Access Compliance Report Public Rights-of-Way (Curb Ramps)

Main Street: LOCH_LOMOND_RD Cross Street: CHESNEY_DR Location: SE

ADA ID: RPAT211201084227 Ramp Type: Type 1 - Perpendicular Diagonal Initial Pass/Fail: Fail Overall Compliance: No Severity Score: 15

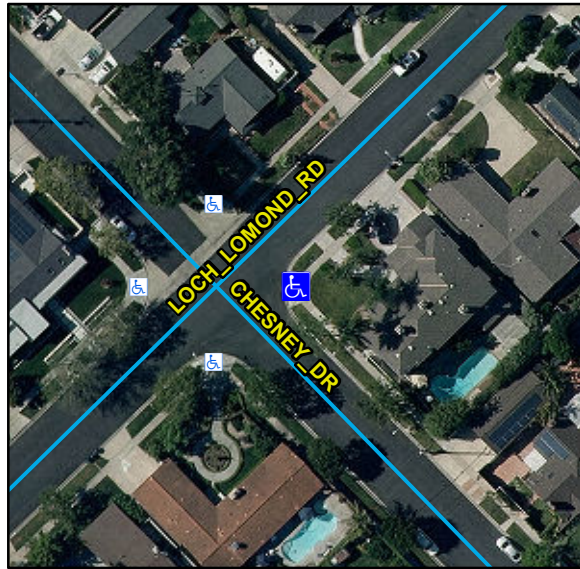
Compliance	Description	Data	Compliance	Description	Data
N/A	Ramp Length (in)	84	N/A	Flare Type LT	
Yes	Ramp Width (in)	48			N/A
No	Ramp Run Slope (%)	8.4	N/A	Flare Slope LT (%)	N/A
Yes	Ramp Cross Slope (%)	0.3	N/A	Flare Traversable LT	N/A
N/A	Landing Present	N/A	N/A	Flare Type RT	
N/A	Landing Length (in)	N/A			N/A
N/A	Landing Width (in)	N/A	N/A	Flare Slope RT (%)	N/A
N/A	Landing Run Slope (%)	N/A	N/A	Flare Traversable RT	N/A
N/A	Landing Cross Slope (%)	N/A	N/A	DWS Provided	N/A
N/A	Landing Movement Obstructed?	N/A	N/A	DWS Contrast	N/A
	Landing Movement Type	N/A	N/A	DWS Length (in)	N/A
N/A	Landing Shared	N/A	N/A	DWS Full Width	N/A
N/A	Clear Space	Yes	N/A	DWS Offset Left (in)	N/A
N/A	Clear Space To Crosswalk (in)	N/A	N/A	DWS Offset Right (in)	N/A
N/A	Marked Crosswalk 1	No	N/A	Marked Crosswalk 2	No
	Crossing 1 Direction	NW		Crossing 2 Direction	SW
	Marked Crosswalk 1 Width (in)	N/A		Marked Crosswalk 2 Width (in)	N/A

Remove & Replace Curb Ramp With Two New Directional Ramps or Equivalent.
